GROUP	MODEL
Safety Recall Campaign	2011-2014MY Sorento (XMa)
NUMBER	DATE
SC284XM	May 2024

### HECU MULTI FUSE REPLACEMENT (SC284XM)

This bulletin provides information to replace the multi fuse of the Hydraulic Electronic Control Unit (HECU) and install an updated junction box label on certain 2011-2014MY Sorento (XMa) vehicles produced from March 3, 2010 through June 14, 2013. An engine compartment fire may occur in the area where the HECU is located. The HECU may experience an internal electrical short circuit condition that can result in overcurrent, thereby increasing the risk of an engine compartment fire while the vehicle is driven or while parked. Dealers are to install new fuses to prevent an electrical short circuit condition in the HECU's electrical circuit board. Customers may experience illumination of the Malfunction Indicator Lamp (MIL), ABS warning light, burning/melting smell, and/or smoke from the engine compartment. Follow the procedure outlined in this publication to install a new multi fuse and junction box cover label on the applicable vehicle. Before conducting the procedure, verify that the vehicle is included in the list of affected VINs.

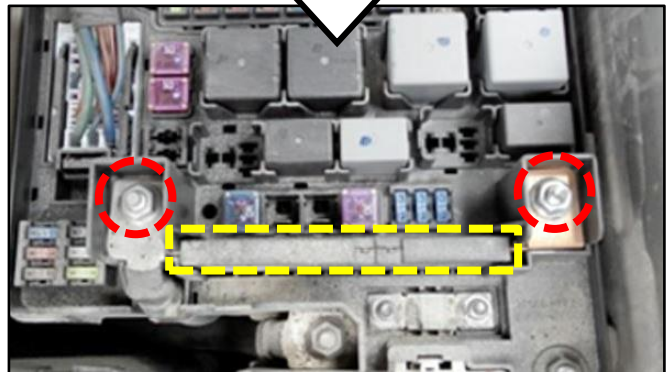
- 4a. Locate the Multi Fuse (A) for ABS1 and ABS2 and loosen the two (2) 10mm Multi Fuse retaining nuts (B) and remove the Multi Fuse.

- 4b. Install the **new** Multi Fuse (A) and tighten the two (2) retaining nuts (B).

Tightening torque for retaining nut (B):  
7.2 - 8.7 lb.ft (9.8 - 11.8 N.m)

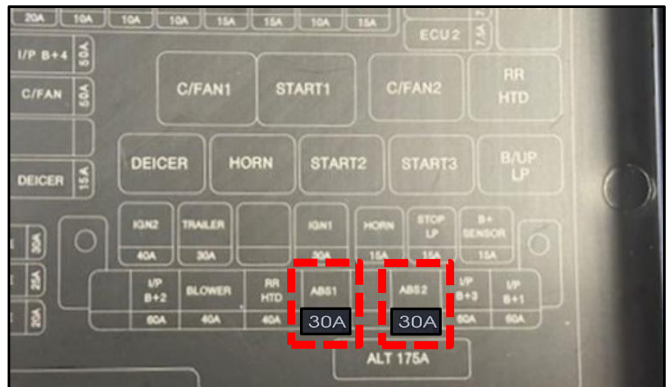
5. Adhere the new ABS1 '30A' and ABS2 '30A' fuse labels to the bottom of the junction box fuse cover, as shown.
